Frio Co. 11.
Sketch file

Surveyor's letter to Evon R.

Dated 11-18-12.

Frio Co. St. File #11

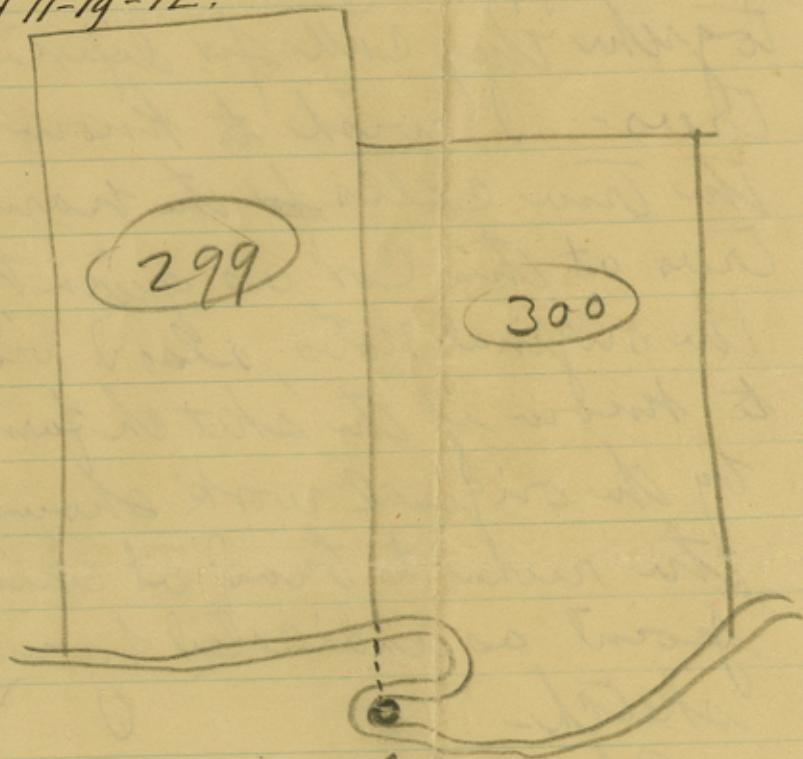
Dear Sir Friend:- A few days
ago I was running out some surveys on
the Leme Riv - this Co. I began at the lower
river cor of No 300, as shown by enclosed
sketch, and ran NW across Sur
no 300, and then ran into the river -
I found the distance to the river short
and found that the river bends as
shown on sketch. I crossed
the river twice and found the
trees called for by Sur No 300
except that from the LO mt \bar{x} the
other two trees stood as follows:-
LO 15 $\frac{1}{2}$ 35 $\frac{1}{2}$ E 13 $\frac{1}{2}$ N - LO 6 $\frac{1}{2}$ 7 E 5 $\frac{1}{2}$

I notice from the field notes
that while these two surveys
are supposed to corner
together they call for different
trees - I wish to know
the true calls for the bearing
trees at this Cor as given by
the original notes, also I wish
to know if the sketch furnished
by the original work shows
the river to bend at this
point as indicated by my
sketch.

Please let me hear from
you at your earliest convenience.
Also please give me your opinion of
the trees I found at this point.
Truly your friend
A. C. Sweeney
Co Surveyor Frio Co

corner identified
on the ground corner tree
with both beams still
standing.
